SANITARY SEWER LAYOUT
LANKIN ADDITION
MAY, 1969
R.S. DELAMATER
CONSULTING ENGINEER
WICHITA, KANSAS

We are handing you herewith the tracings for the 48" storm sewer and the sanitary sewer which have been constructed to serve the Lankin Addition.

These tracings have been corrected to indicate the grades and dimensions as built and also to include the connecting lines into the sewers; in the case of the storm sewer we have indicated the location, flowline and grate elevation of the inlets which discharge into the manhole at the eastern end of the line.

48" STORM SEWER LAYOUT
LANKIN ADDITION
May, 1969
R.S. DELAMATER
CONSULTING ENGINEER
WICHITA, KANSAS

231-A-108

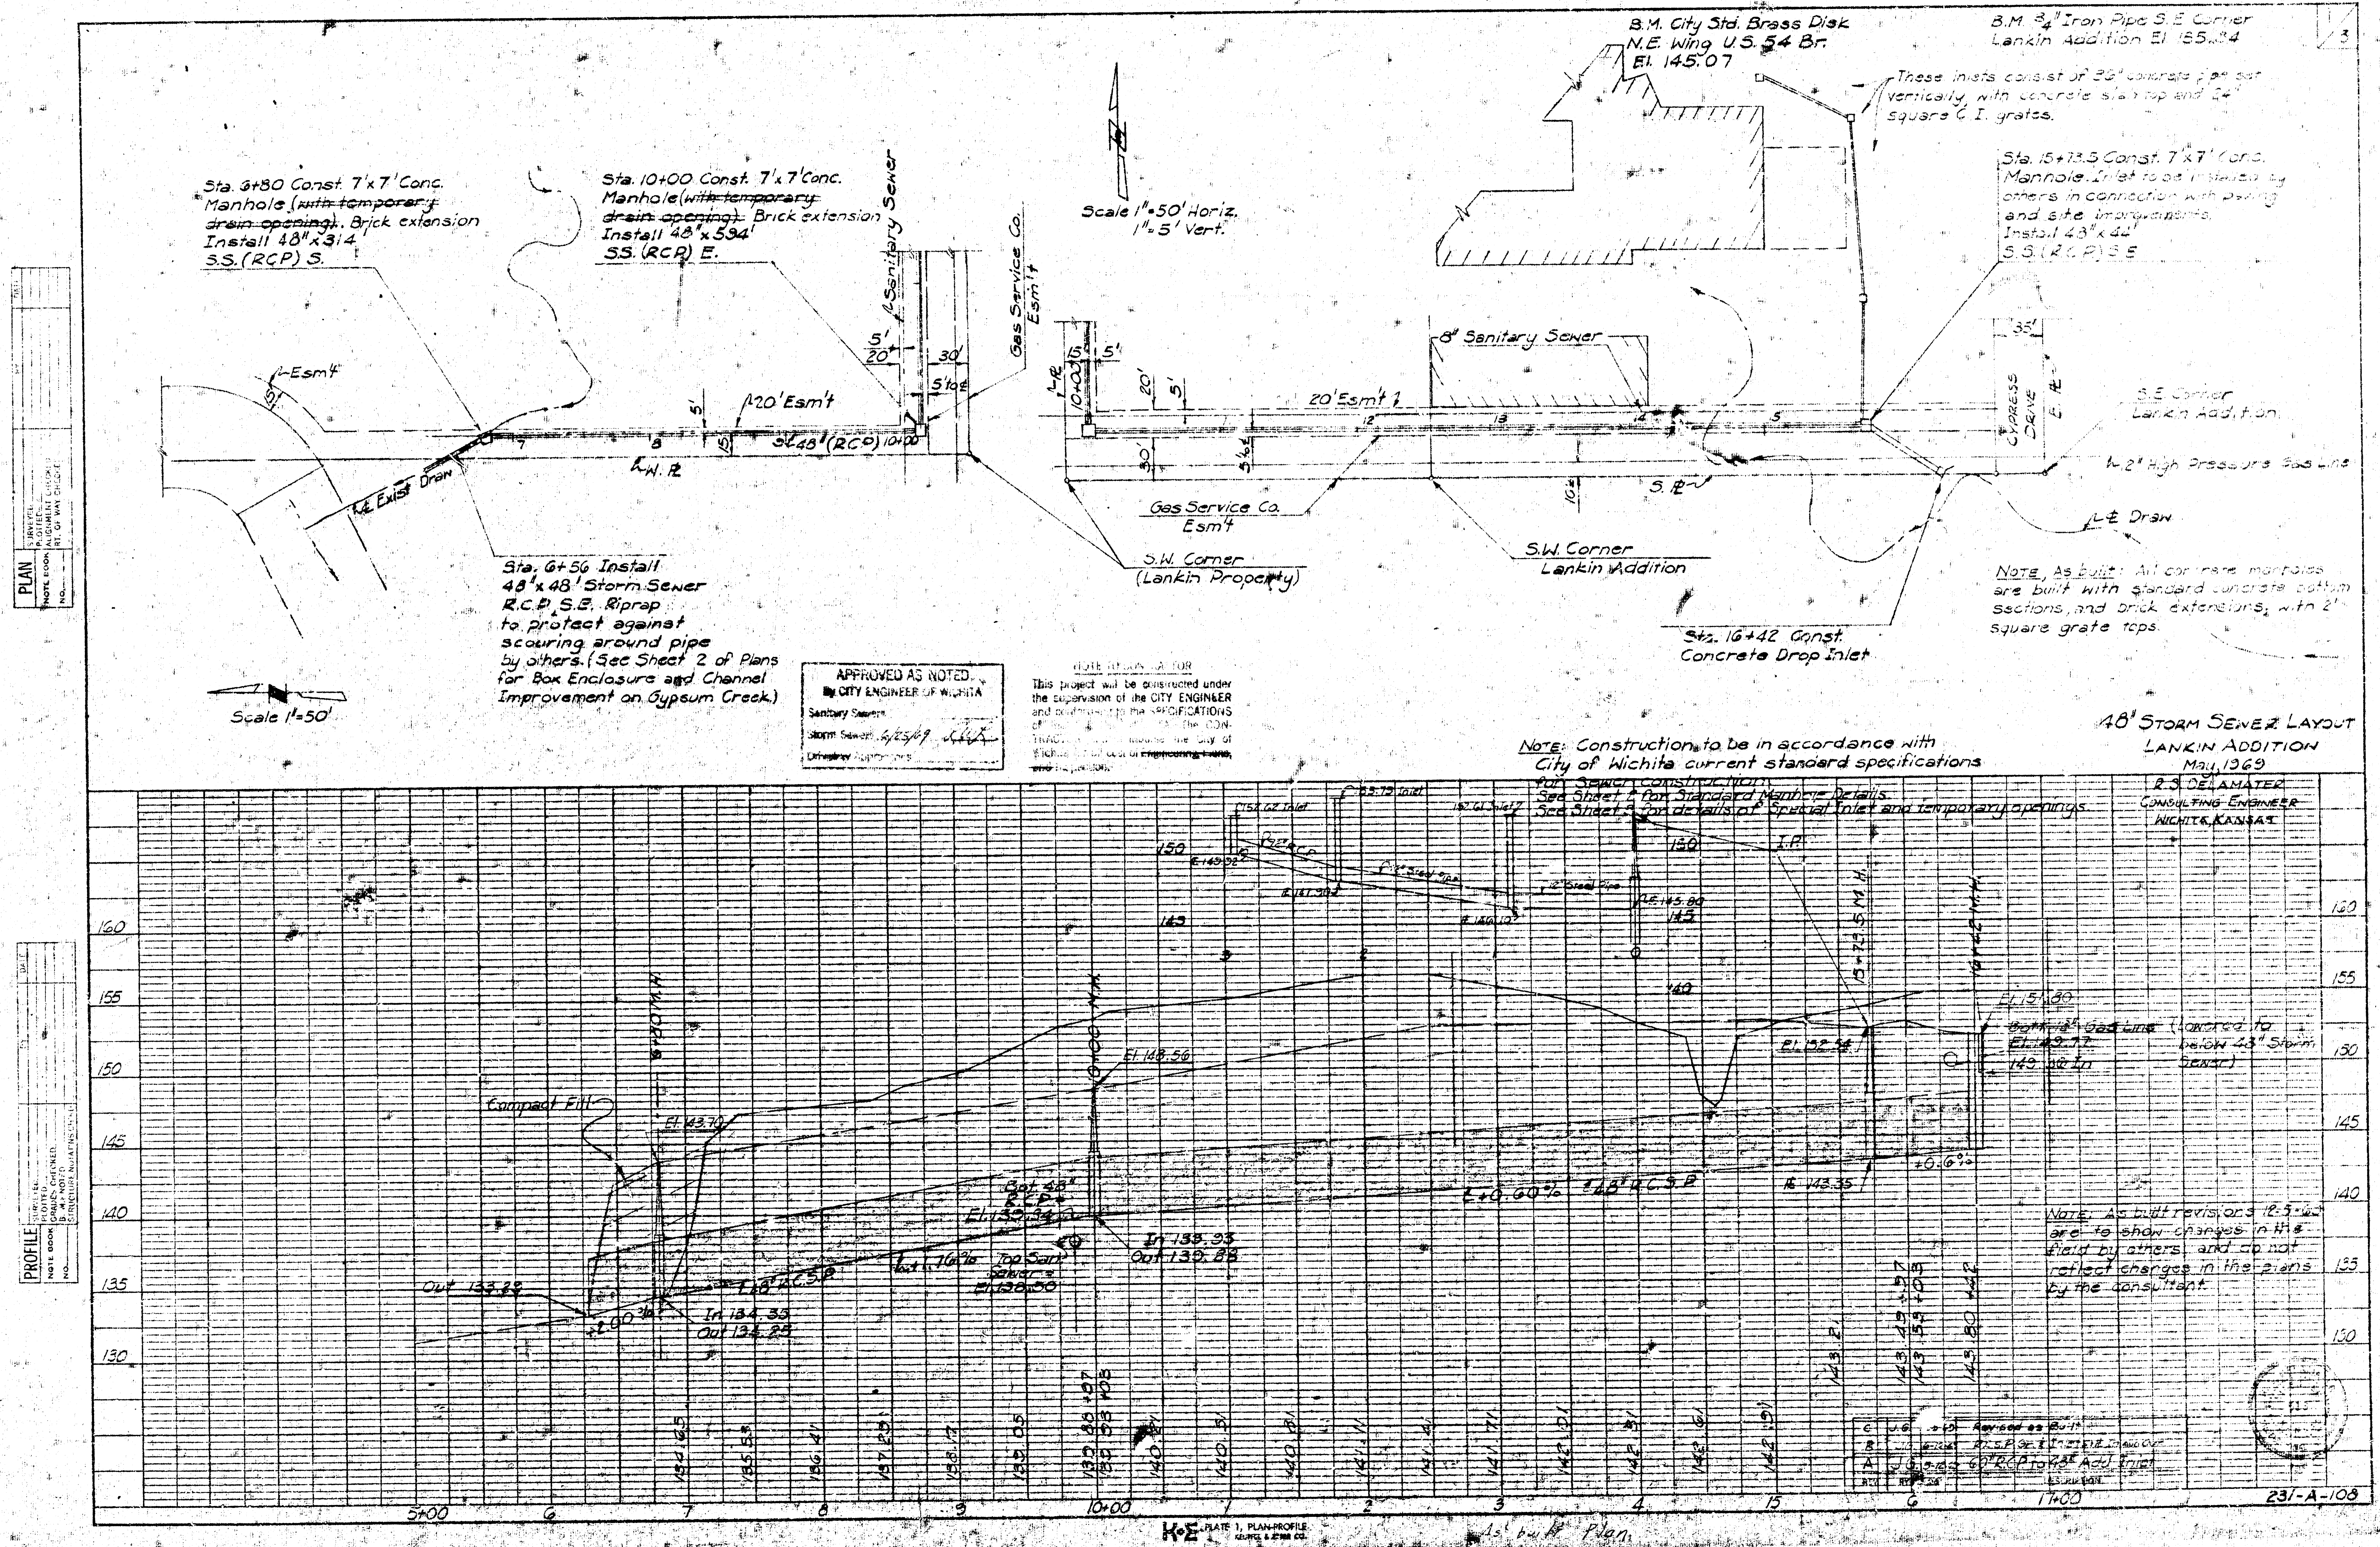
NOTE, As built: All concrete manholes are built with standard concrete bottom sections, and brick extensions, with 2' square grate tops.

NOTE: Construction to be in accordance with City of Wichita current standard specifications ~~for Sewer construction.~~
~~See Sheet 2 for Standard Manhole Details.~~
~~See Sheet 3 for details of Special Inlet and temporary openings.~~

NOTE: As built revisions 12-5-69 are to show changes in the field by others, and do not reflect changes in the plans by the consultant.

REV.	BY	DATE	DESCRIPTION
C	J.G.	[illegible]	Revised as Built
B	J.G.	6-[illegible]	R.C.S.P. for [illegible] Inlet & Drainage
A	J.G.	5-69	60" RCP to 48" Add. Inlet
